# UNITED STATES PATENT AND TRADEMARK OFFICE

10/586,195

David Bottomley

<i>Office Action Summary</i>	Application No.	Applicant(s)	
	10/586,195	BOTTOMLEY ET AL.	
	Examiner	Art Unit	
	ERNESTO GARCIA	3679

**FIG 3**

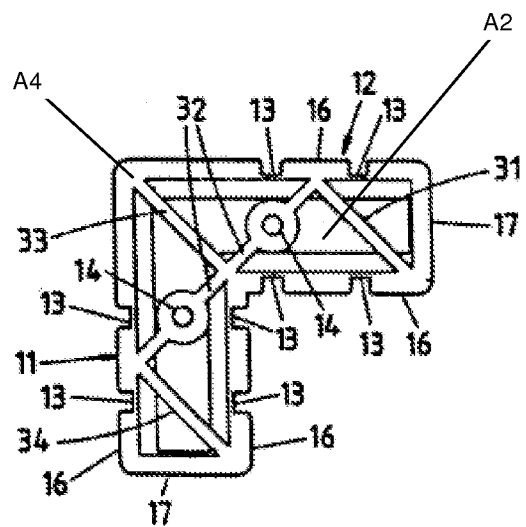
Regarding claim 1, Murphy et al. discloses, in Figure 3, a bracket comprising a body portion A1 (see marked-up attachment) and one or more arm portions 17 extending from the body portion A1. The arm portions 17 include at least one pair of parallel grooves 13 and at least one recessed region A2. Applicants should note that the parallel grooves 13 can be adapted to releasably engage complementary lips of the strut and the recessed region A2 can be adapted to securely engage one or more crimped portions of a strut.

Regarding claims 2 and 3, the grooves 13 and the recessed region A2 are arranged.

Regarding claim 4, the body portion comprises an upper face A3, lower face A4, and side faces A5.
